STAFF RECOMMENDATION 1707 Blair Boulevard July 19, 2017

Application: New construction—addition and outbuilding
District: Belmont-Hillsboro Neighborhood Conservation Zoning Overlay
Council District: 18
Map and Parcel Number: 10416009000
Applicant: Martin Wieck, Nine12 Design
Project Lead: Melissa Baldock, melissa.baldock@nashville.gov

Description of Project: Application is to construct an addition to an historic house with a mid-way parking pad and to construct a detached building at the rear with 4 attached parking bays. The historic house and addition will have four dwelling units in it, and the rear structure will have one dwelling unit in it.

1 ROOF PLAN

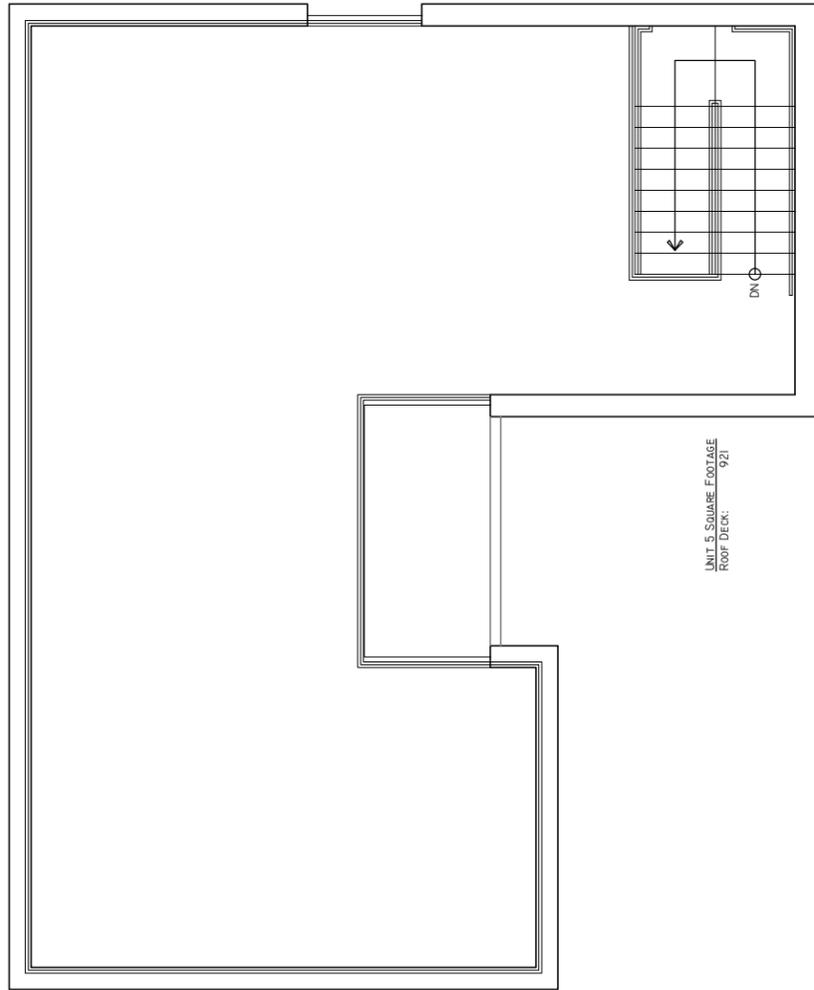
Addition Roof form: The addition includes a flat-roofed dormer that ties into the back of the historic house at a point six inches (6”) below the ridge. The dormer is inset two feet (2’) from the side walls of the house, which is appropriate. As mentioned under “Height and Scale,” staff finds that the flat roof form of the dormer accentuates the height of this part of the addition. Typically, rear dormers have a slope to them, even if it is a slight shed slope. The thirty-six feet, six inch wide by twenty-seven feet (27’) deep dormer will appear more like a roof top addition than a rear dormer. Staff recommends that the dormer have a minimum 3/12 slope to it.

The rest of the addition has a flat roof form. The design guidelines state that new construction should have a slope of at least 6/12, and also states that “*Visually evident roof slopes should match the roof slopes of the existing structure, and roof planes should set in accordingly for rear additions.*” Staff finds that a flat roof form is appropriate in this instance because the historic house is a two-and-a-half story house. The top of the addition’s parapet will be just two feet (2’) taller than the historic house’s eaves and will be several feet shorter than the ridge of the house. The addition is also over fifty-three (53’) back from the front of the house and will not be highly visible from the public street.

With the condition that the rear dormer have a slope of at least 2/12, staff finds that the addition’s roof forms meet Section II.B.1.e. and II.B.2. of the design guidelines.

3 UNIT 5 SOUTH ELEVATION
SCALE: 1/8"=1'-0"

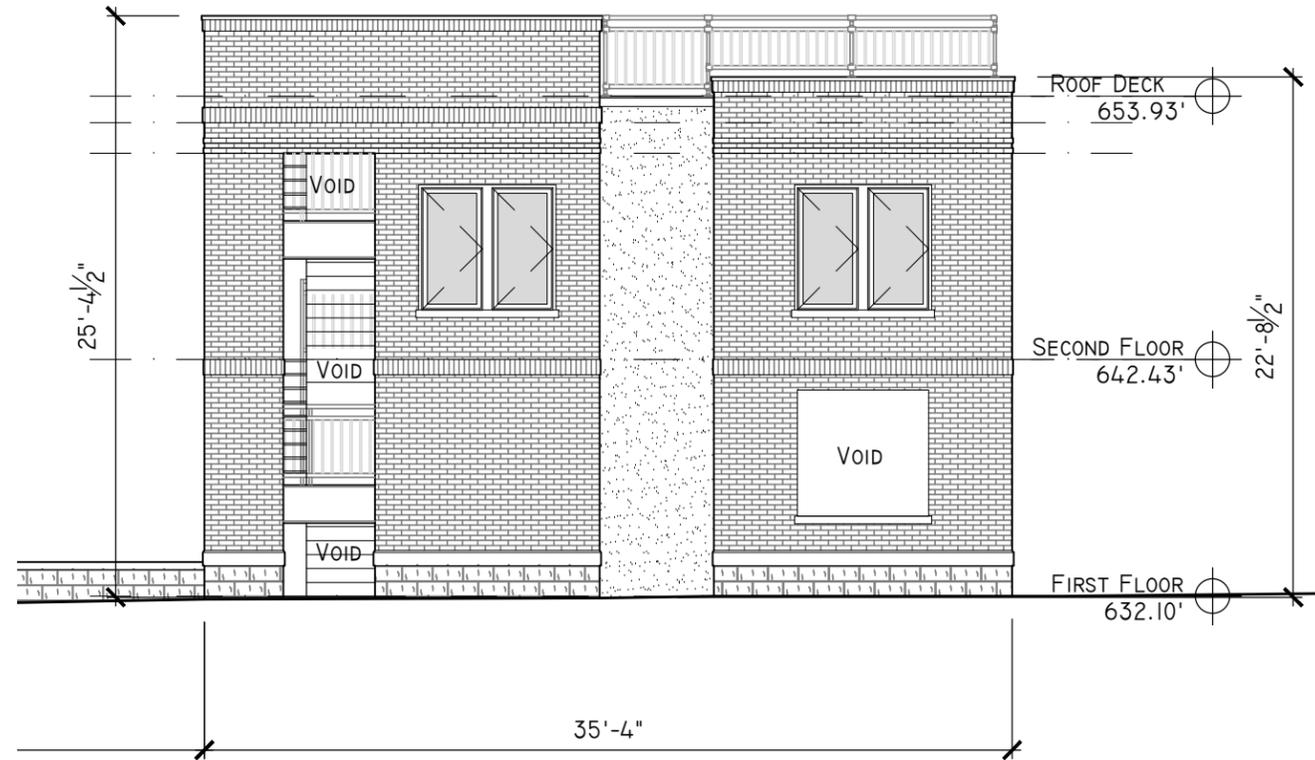
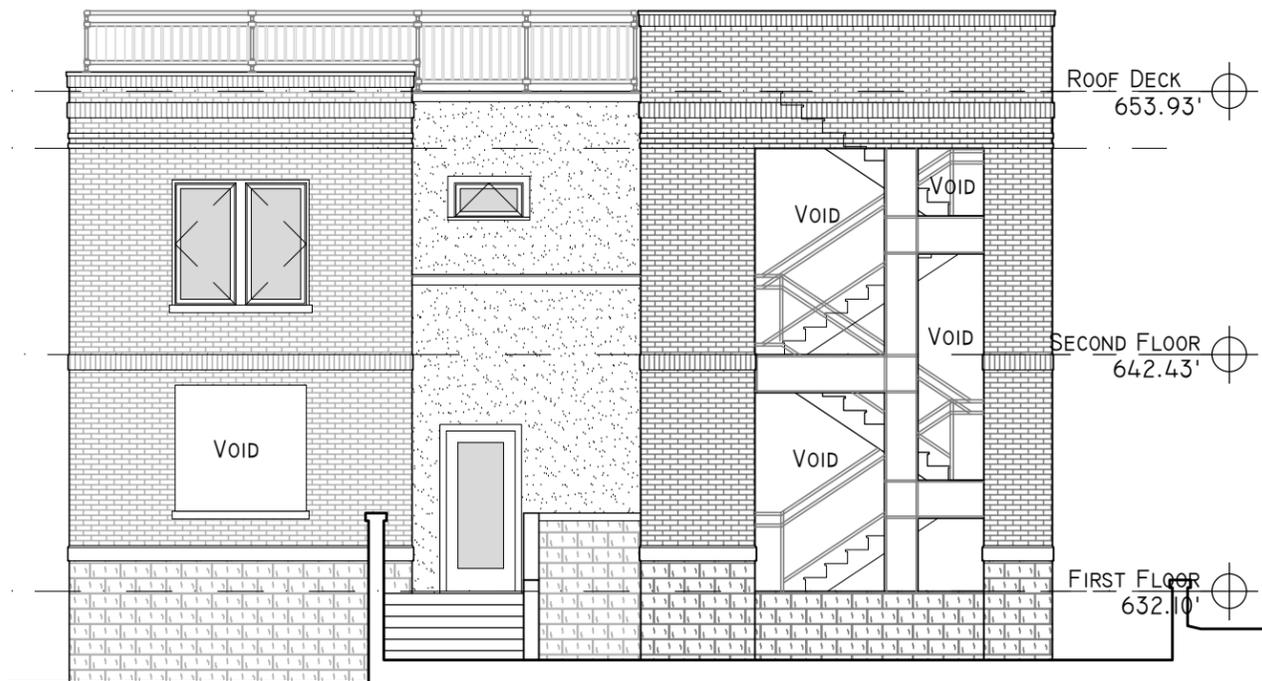
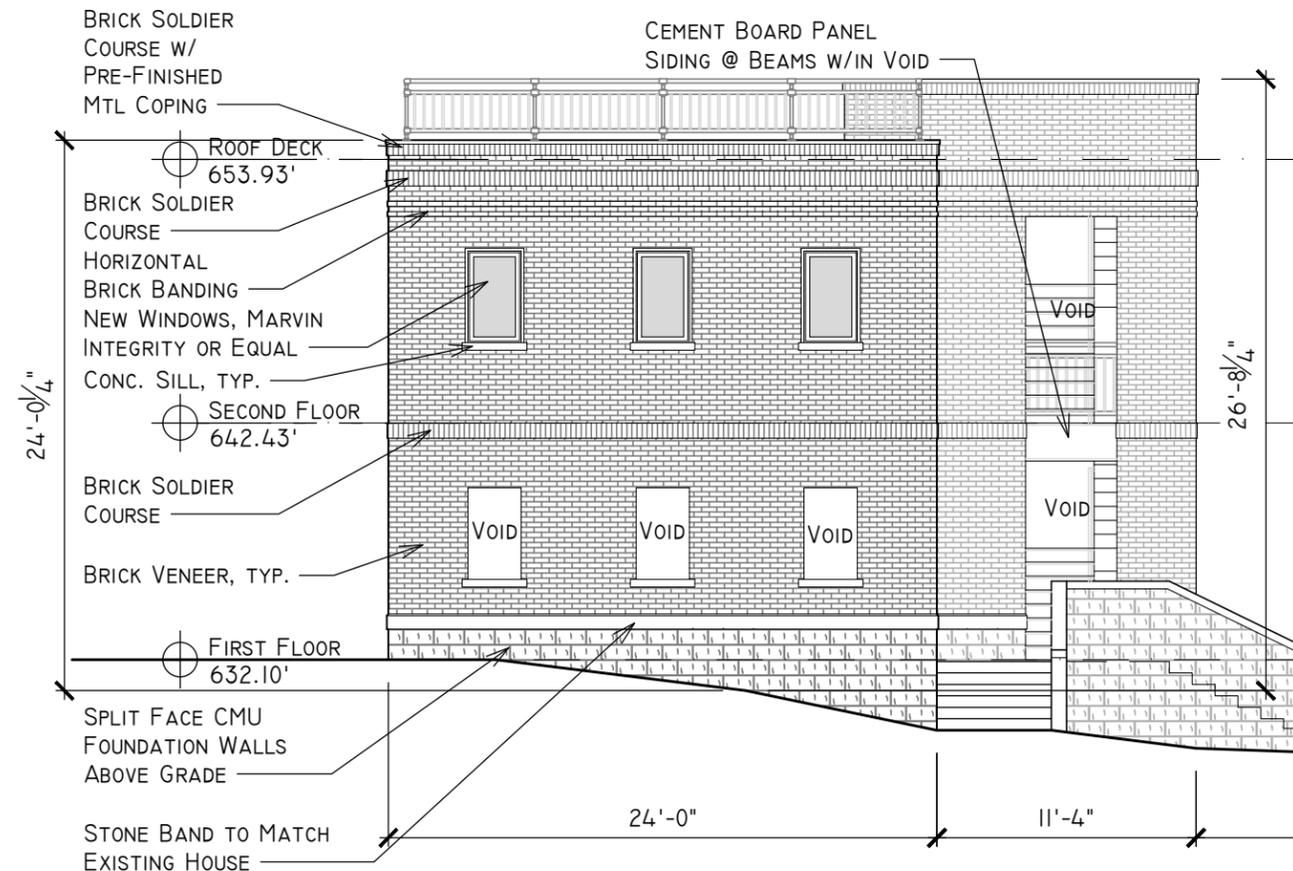
The proposed outbuilding has a semi-enclosed stairwell, facing the back of the house/addition. Portions of the side and the top are uncovered. The design guidelines state that outbuildings should have stairways that are enclosed. Staff recommends full enclosure of the stairs.

1. The dormer roof have minimum 3/12 slope to it;
2. The railing of the addition step in two feet (2') on each side;
3. The front porch and front stoop on the left side remain unconnected;
4. Staff approve the windows and doors prior to purchase and installation;
5. Staff approve a brick sample;
6. Staff approve the material and design of all balconies;
7. Staff approve the exterior stair material;
8. Staff approve the HVAC location; and
9. The exterior stairs on the outbuilding be enclosed.
